Kyle Canyon Gateway

Architectural Review Committee

Re: Kyle Canyon Gateway Planned Development
Tri Pointe Homes ("Master Developer")
Arrow Peak - Unit 1 (the "Subdivision")

EX-1
 SHEET 1 OF 2

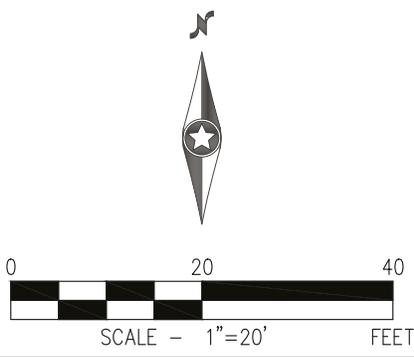
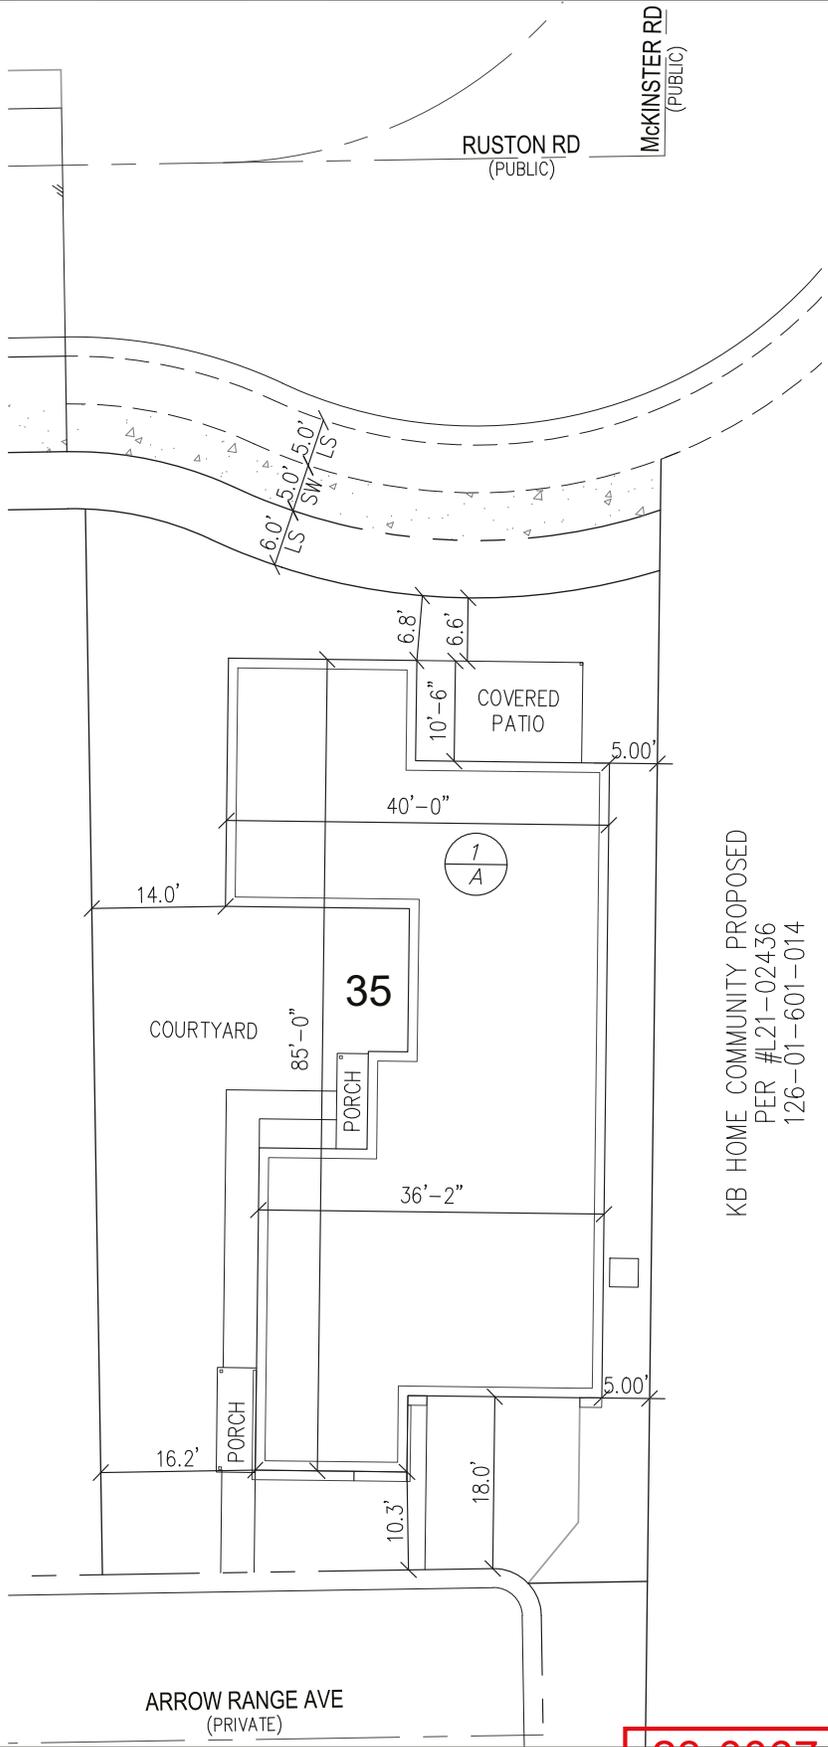
1. Reversed Plan 1 (driveway toward the west) with a 6.7' minimum rear setback to living where 12' minimum is required and 8.5' minimum rear setback to the covered patio
2. Standard Plan 1 (driveway toward the east) with a 6.8' minimum rear setback to living where 12' minimum is required and 6.6' minimum rear setback to the covered patio

The Kyle Canyon Gateway Architectural Review Committee has reviewed all relevant documents and approves the Subdivision's reduced rear setback request for Arrow Peak Plan 1 on Lot 35 as outlined in the two scenarios above.
